UNITED STATES PATENT AND TRADEMARK OFFICE

APPLICATION NO.	FILING DATE	FIRST NAMED INVENTOR	ATTORNEY DOCKET NO.	CONFIRMATION NO.
10/517,321	08/23/2005	Per Mansson	Mans3012/REF	3651
23364	7590	10/19/2007	EXAMINER	
BACON & THOMAS, PLLC			JUNG, UNSU	
625 SLATERS LANE			ART UNIT	
FOURTH FLOOR			PAPER NUMBER	
ALEXANDRIA, VA 22314			1641	
			MAIL DATE	DELIVERY MODE
			10/19/2007	PAPER

Office Action Summary

DETAILED ACTION

Fig.2

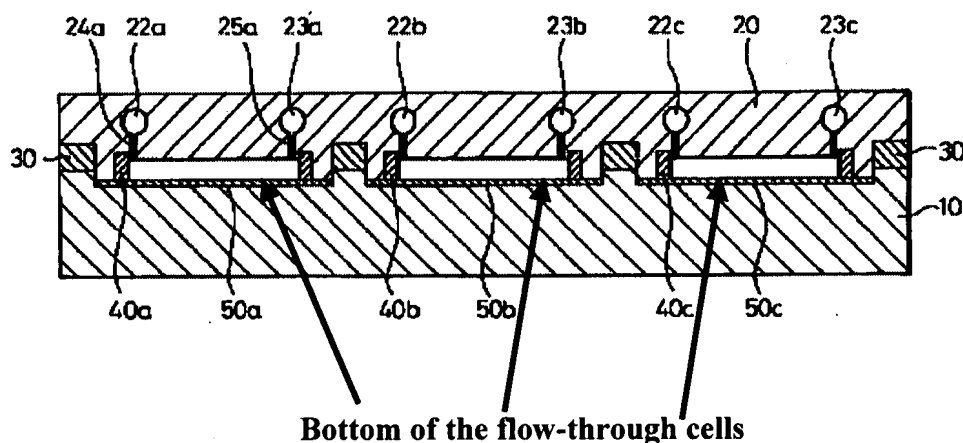
Applicant's interpretation of the element 10 of Kawakami et al. (in Fig.'s 2 and 3), which serves as both connecting panel and the bottom of the flow-through cell is not found persuasive. Applicant correctly interprets that element 10 of Fig.'s 2 and 3 represents connecting panel. However, the bottom of the flow-through cells is not represented by element 10 of Fig.'s 2 and 3 but rather by 50a. This is more clearly illustrated in annotated Fig. 2 below:

Kawakami et al. teaches a flow-through cell as illustrated in Fig. 2 above, in which entrance and exit holes, 22b and 23b, respectively (column 8, lines 32-40), provide flow through cell compartments, which also house the oscillators (50a-c). Therefore, one of ordinary skill in the art would reasonably interpret that the each cell compartment of Fig. 2 as a flow-through cell, which encases the piezoelectric crystal microbalances.

Applicant's argument that connecting panel 10 of Kawakami et al. does not have pair of fluid connecting ports located within the connector portion is acknowledged. However, both elements 110 and 20 of Kawakami et al.'s (see Fig. 2 above) can be interpreted as the connecting station, which has the fluid connecting ports located within element 20.
